22Jan2019

Re: Evaluation of Alternates to the Proposed Menemsha Bus Turn-around

We are in receipt of three individual alternative plans to the bus turn-around proposed in our report, dated 27Aug2017. These alternatives have been transmitted by your Office, with your request for review and evaluation with regard to the original design criteria.

Alternative to Current Bus Turnaround Plan
(revision of 8/20/2017 Brewster Architects Plan)
Submitted by Barbara Armstrong. 1/7/19

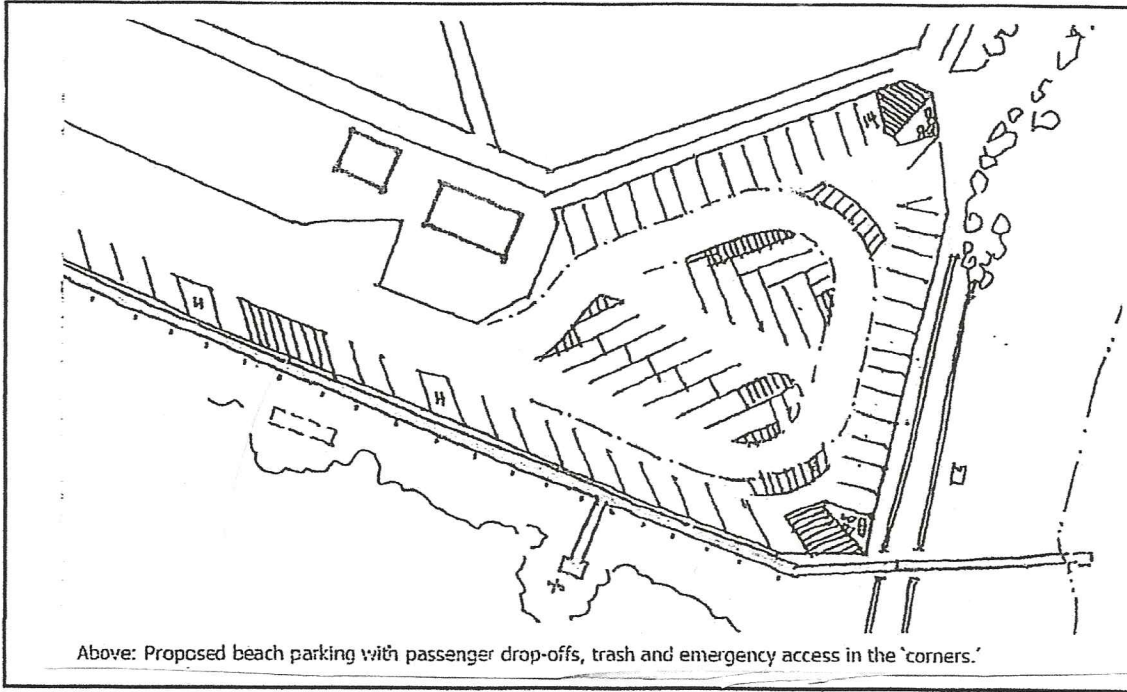
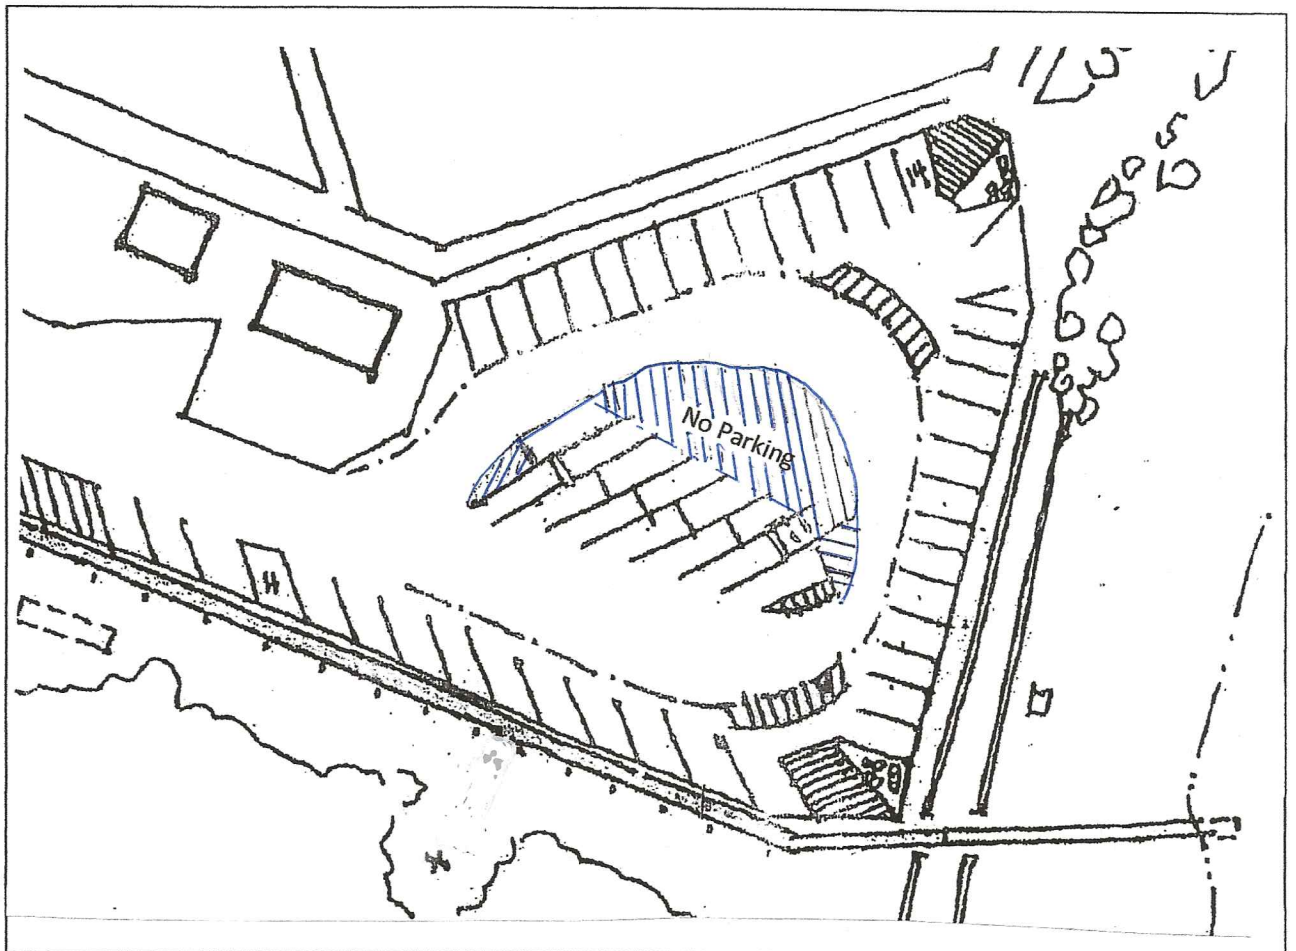
- A narrative is provided to further understand the Armstrong Proposal's intent.
 - This proposal shows the western portion of the central parking layout eliminated with the single-lane, one-way traffic loop moved inboard.

- This central area will be marked as No Parking/Emergency Vehicles only.
 - Possible Moped and bicycle parking may be provided.
 - No change to the perimeter spaces, drop-of points or corner loading is indicated.

- a. Advantages
- This eliminates the need for the bus turn-around near the Comfort Station.
 - Provides an enlarged traffic lane for buses/emergency vehicles along the western turn, potentially improving traffic flow.

- Provides for emergency vehicle staging/parking.
 - Provides for additional moped and bicycle parking.
- b. Disadvantages
- To accomplish this, a reduction in total parking spaces is necessary, eliminating 7-9 of the parking spaces shown in item B3, above (Brewster Architects Plan).

- o The traffic lane indicated in the Plan by Brewster Architects reflects a passenger vehicle lane width and turning radius.
 - Without the bus turn-around at the Comfort Station, the radius and lane width would require significant increases to accommodate transit buses, resulting in the additional loss of parking in the central area and would require confirmation through engineering.
 - The Armstrong Proposal recommends the use of smaller transit buses as noted in their recommendation #1. We will defer to the VTA regarding ridership, routing, bus size, etc.

As noted under general observations, the proposal eliminates parking. And while this proposal attempts to address traffic flow by shifting the traffic lane, it does not consider the additional turning radius and lane width required to do so for buses vs. passenger vehicles shown in the Brewster Architects plan.
